December 23, 2009

RE: Scoping comments for the Chevron-Solar Millenium Palen and Blythe solar projects and the Nextera (FPL) Genesis solar project

These comments are being submitted on behalf of the California/Nevada Desert Energy Committee of Sierra Club. Most of the comments apply to all three projects; where noted, the comments are project-specific.

Figure 1. Dry Lake proposed alternative Solar Energy Study Area, Nevada. Cross-hatched area represents the NWP proposed SESA.

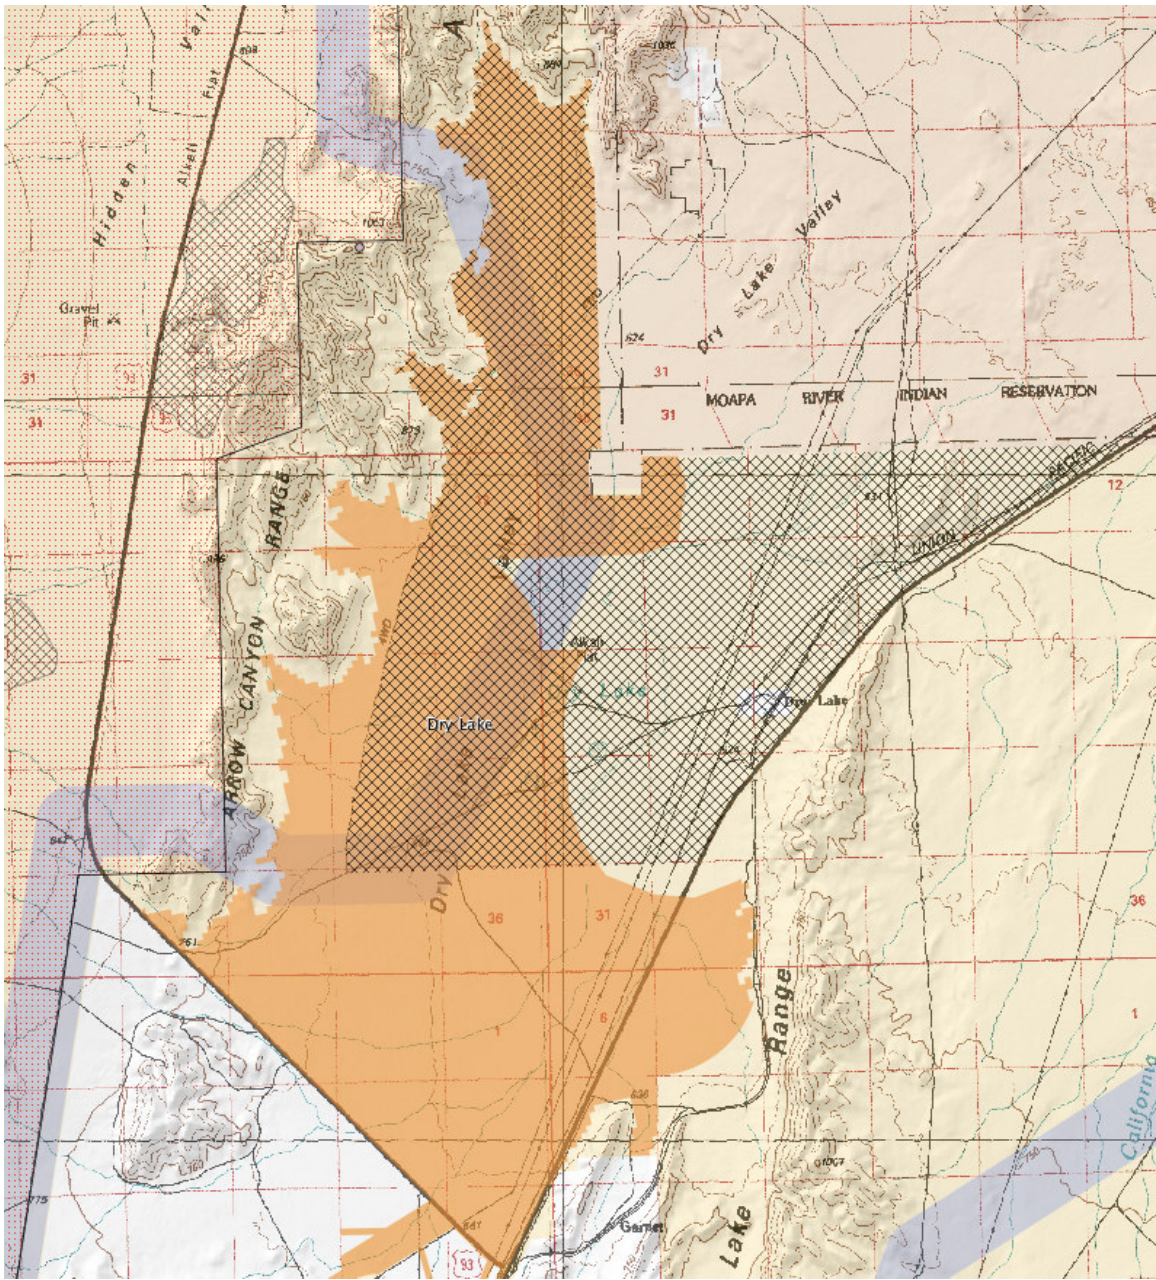
of the current SESA are excluded. The alternative SESA is approximately 13,500 acres (see Figure 1).

Figure 1. This map depicts overlap and conflict of the Mason Draw SESA with the New Mexico Wilderness Alliance's BLM Citizen's Wilderness Inventory Units.

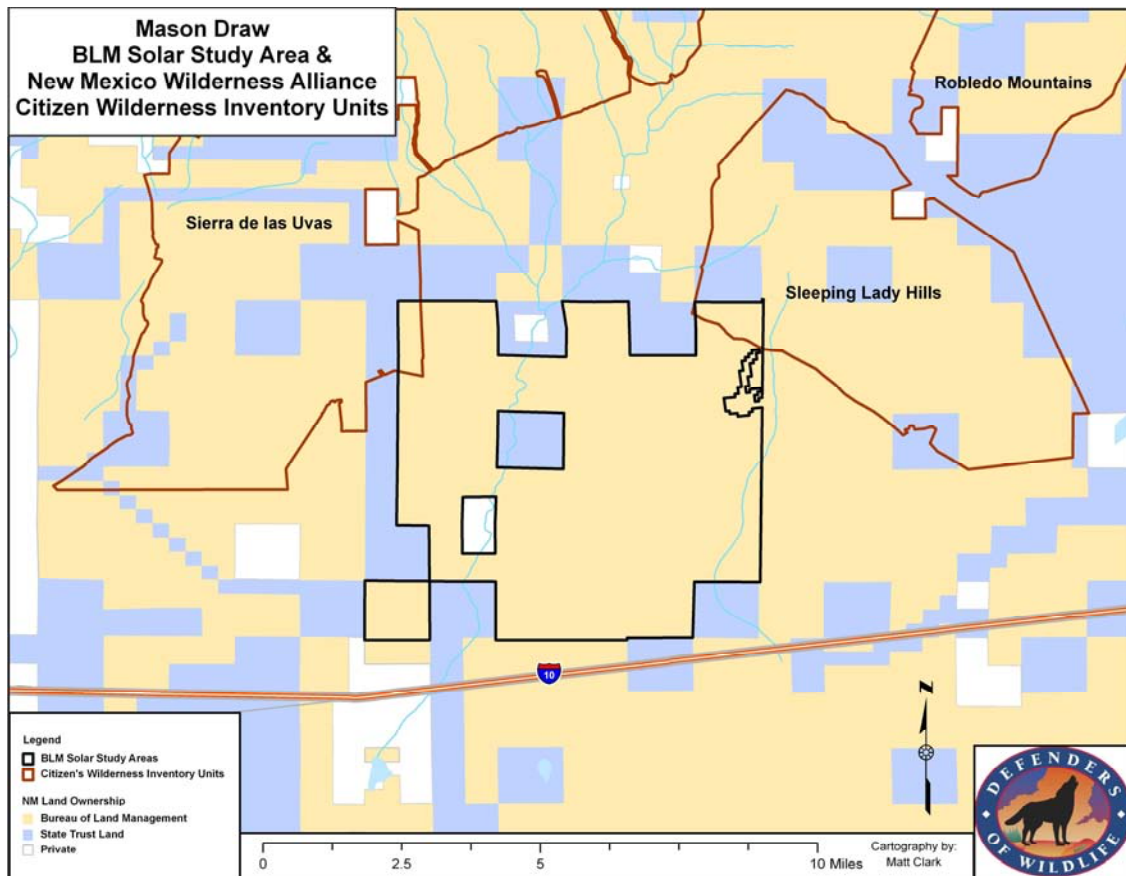
- o This SESA intersects southwestern corner of New Mexico Wilderness Alliance (NMWA) BLM Citizens' Wilderness Inventory Unit "Sleeping Lady Hills" by approx. 350 acres and also clips the "Robledos-Las Uvas" unit by approx. 480 acres (see Figure 1; GIS data for the NMWA Citizens' Wilderness Inventory Units included in Exhibit 2 of broad comments submitted under the same cover as these New Mexico-specific comments). This overlap is unacceptable and unnecessary – the Mason Draw SESA should, at a minimum, be redrawn to exclude these inventory areas.

Recommendations: At the very least, BLM should revise the boundary of the Mason Draw SESA to exclude the overlap with the NMWA Citizens' Wilderness Inventory Units. Based on potential resource conflicts and issues raised by the BLM Las Cruces

Figure 2. This map depicts overlap and conflict of the Mason Draw SESA with the BLM Habitat Management Planning Area for pronghorn and mule deer.

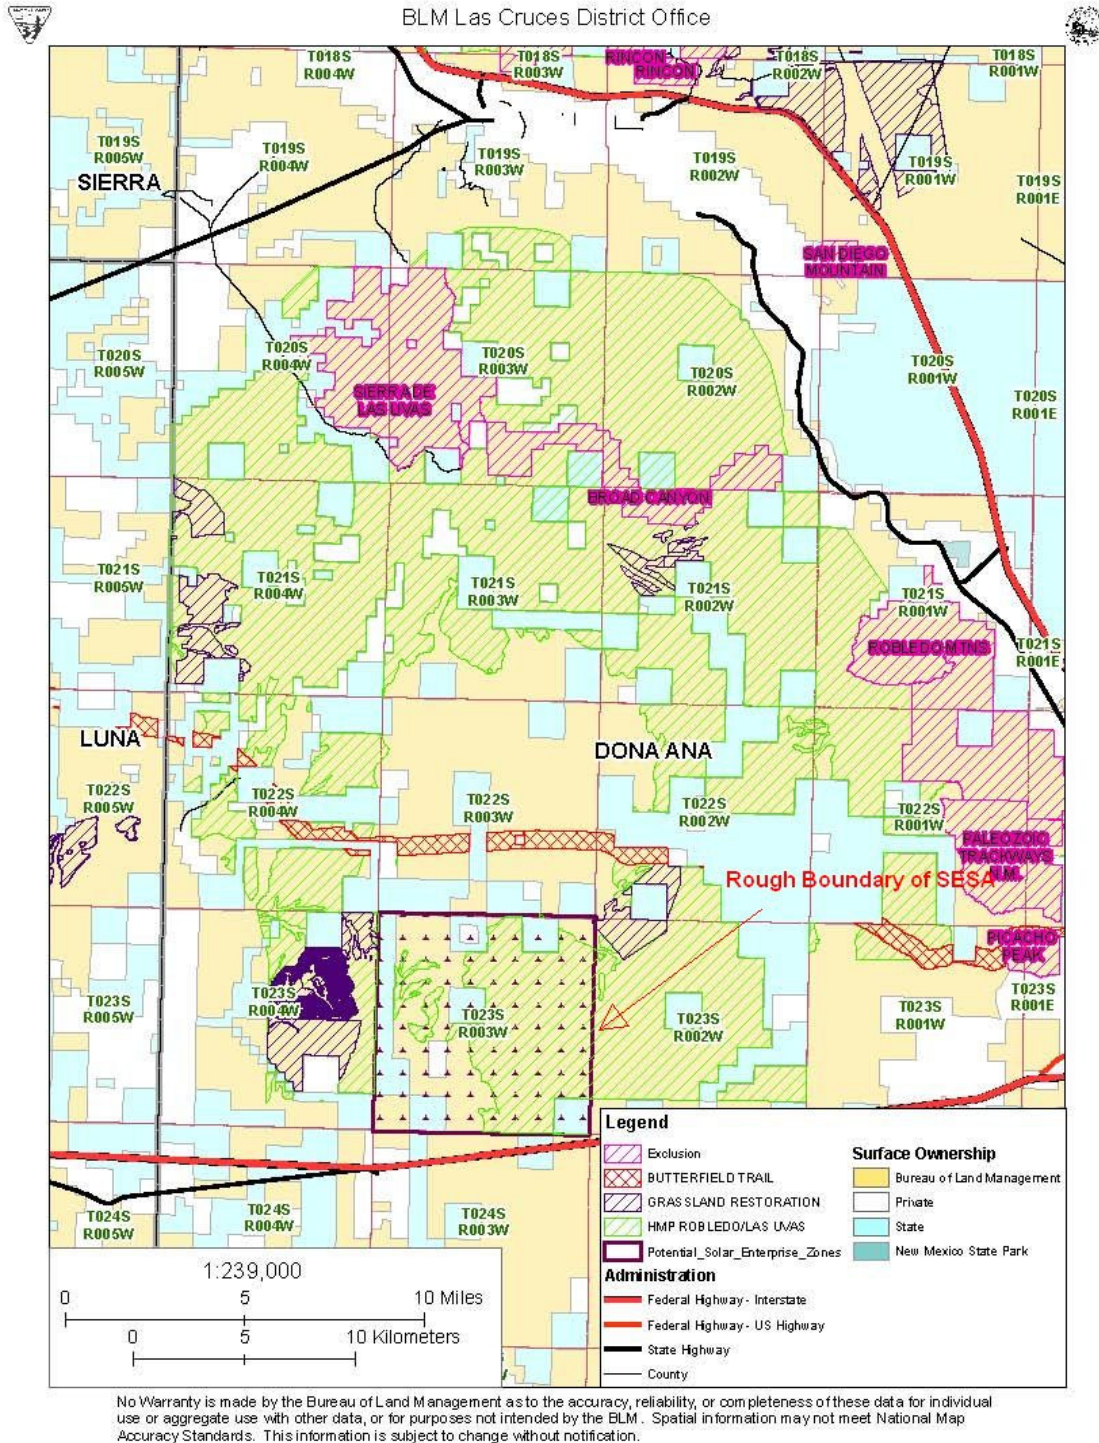
- o This SESA is located within a BLM Habitat Management Planning area for pronghorn and mule deer (see Figure 2). Industrial solar development is not consistent with maintaining and/or improving habitat for these two species, both of which are very sensitive to roads, traffic, human development and disturbance.
- o The Nature Conservancy (TNC), in cooperation with the BLM and other entities, conducted a Rangeland Ecological Assessment (REA) for the southern half of New Mexico. In this assessment, there are two areas totaling approximately 1,000 acres in the west and south of the Mason Draw SESA mapped as "unresolved", that may contain some grassland reference condition elements².

Figure 3. This map depicts the Red Sand Solar energy study area in relation to mapped units of TNC's Rangeland Ecological Assessment reference conditions.

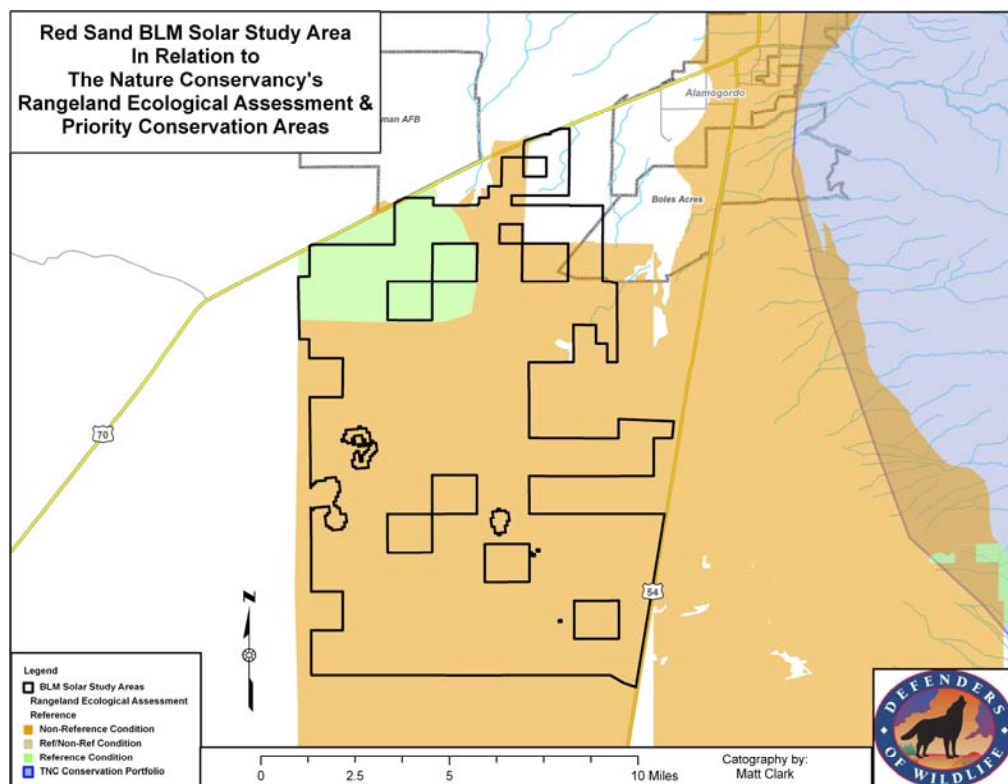
- o TNC's Rangeland Ecological Assessment identifies a grassland area in the northwestern portion of this SESA that contains approximately 6,400 acres of reference condition-quality grasslands (See Figure 3). Reference condition Chihuahuan desert grasslands are very rare, and BLM should carefully consider whether they are appropriate for inclusion in the SESA.

Recommendations: Based on conflicts identified by the BLM Las Cruces District Office and our own analysis, including the presence of playa lakes within the site, the extensive nature of the cultural resources, the development of habitat restoration projects underway in BLM's Renewable Resources division, and the presence of reference condition-quality grasslands as mapped by TNC, BLM should carefully consider whether or not to include all or some part of this area as a SESA. If the SESA is included, BLM should analyze the potential impacts of designating the SESA and the impacts of potential solar development in the SESA, identify opportunities to minimize and mitigate any potential impacts in the Draft PEIS, and require that impacts be minimized and mitigated.

Figure 5. This map depicts the Red Sand SESA in relation to NMWA Citizens' Wilderness Inventory Units and playa lakes.

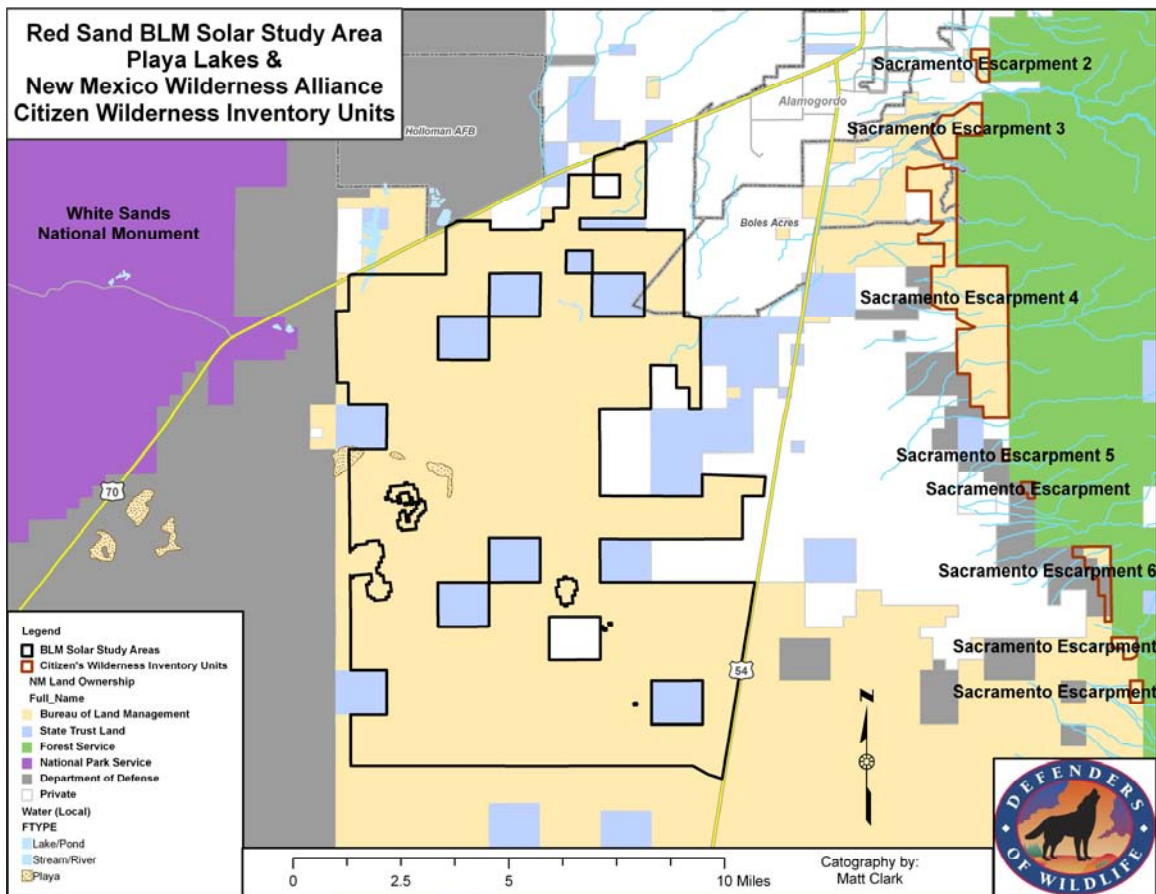
- o The BLM Renewable Resources division is currently developing habitat restoration projects in this SESA. To the extent that lands within this SESA are targeted by BLM and conservation organizations for grassland restoration, BLM should carefully consider whether these areas should be included in the SESA. Figure 4 shows TNC's REA mapped restoration potential.
- o This SESA contains several playa lakes, which provide seasonally important habitat and water sources for migrating birds and other wildlife species (See Figure 5).

Figure 6. This map depicts the Afton Solar Energy Study Area in relation to the USGS Southwest ReGAP wildlife habitat modeling reptile richness composite. Note the area in the eastern portion of the study area that contains relatively high reptilian richness.

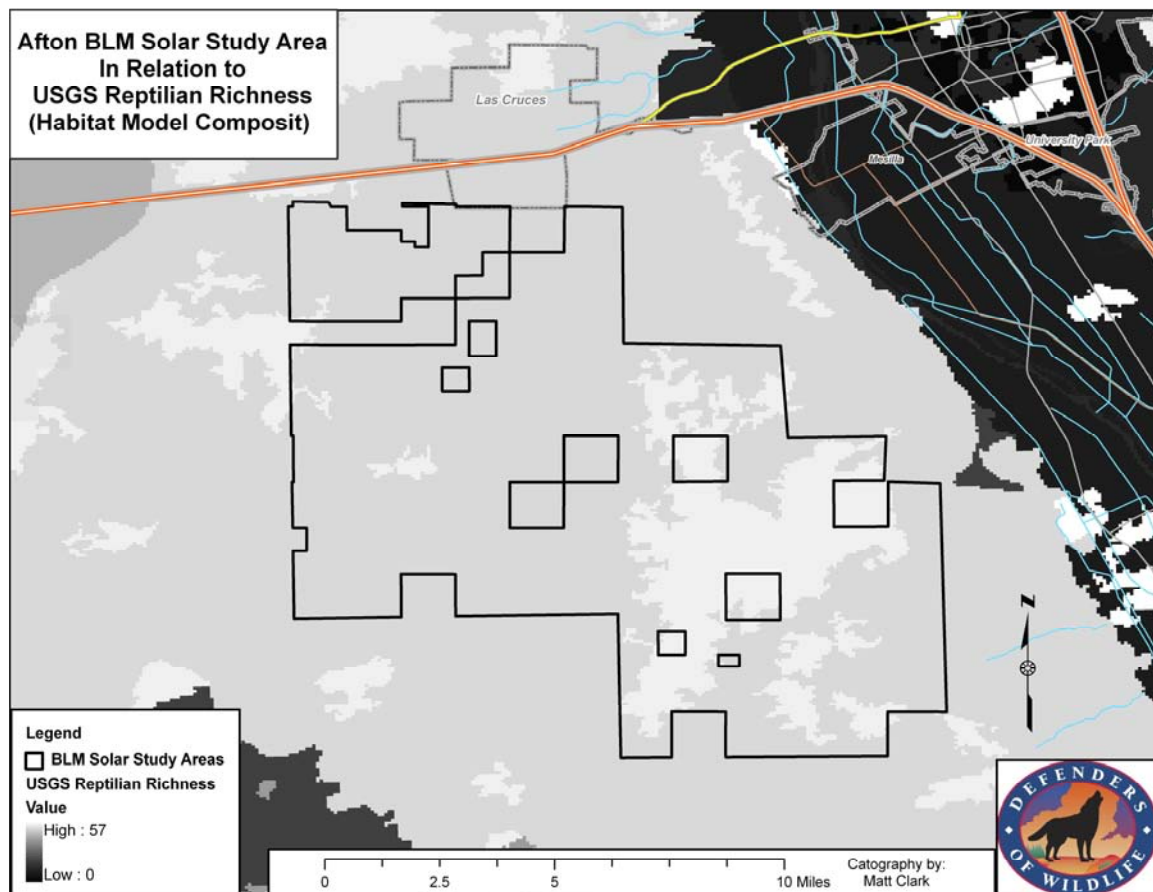
- Of the three SESAs in New Mexico, this unit appears to have the least conflict with sensitive natural resources. It is also close to existing infrastructure (Interstate 10 and an “existing designated corridor”) as well as a major metropolitan area (Las Cruces).
- According to USGS Southwest ReGAP terrestrial species predicted range modeling species richness composite, this SESA has high reptilian diversity in the eastern half (45 on a scale of 0-57) (See Figure 6).

Recommendations: Because it represents the SESA with the least amount of conflict in New Mexico, BLM should study the Afton SESA in detail in the Draft PEIS to determine whether the area is appropriate for solar development. BLM should also closely analyze areas with high reptilian diversity in the eastern portion of the SESA, and if serious conflicts are found the agency should consider avoiding them for solar development. BLM Las Cruces District Office has indicated that there may be areas adjacent to the Afton SESA which might be appropriate for inclusion in the SESA⁴ – BLM should evaluate those areas to determine if they are appropriate for inclusion. BLM should

Figure 7. This map shows the close proximity of the Afton SESA to the Aden Lava Flow Area of Critical Environmental Concern.

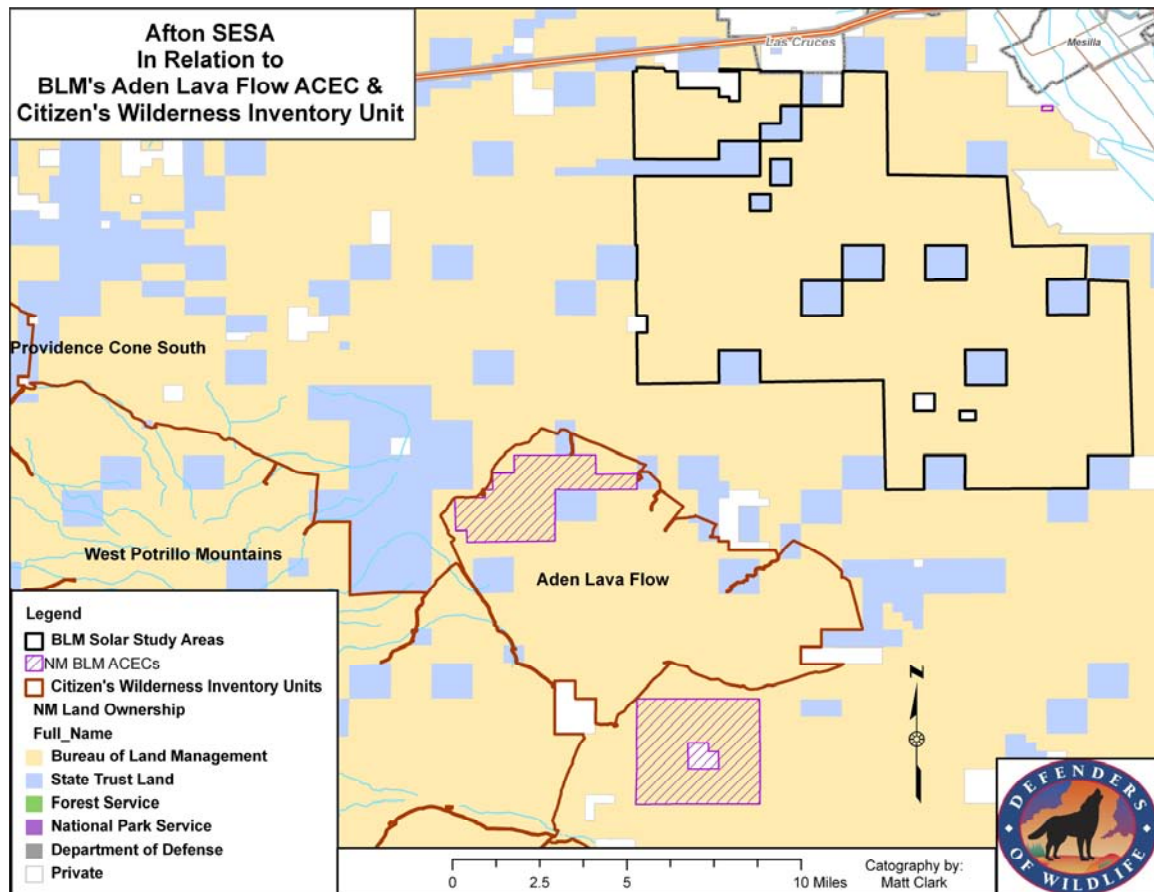
analyze the potential impacts of designating the SESA and the impacts of potential solar development in the SESA, identify opportunities to minimize and mitigate any potential impacts in the Draft PEIS, and require that impacts be minimized and mitigated. BLM should also analyze the potential impacts of nearby industrial-scale solar development on the scenic and habitat values of the Aden Lava Flow ACEC (see Figure 7 for proximity).
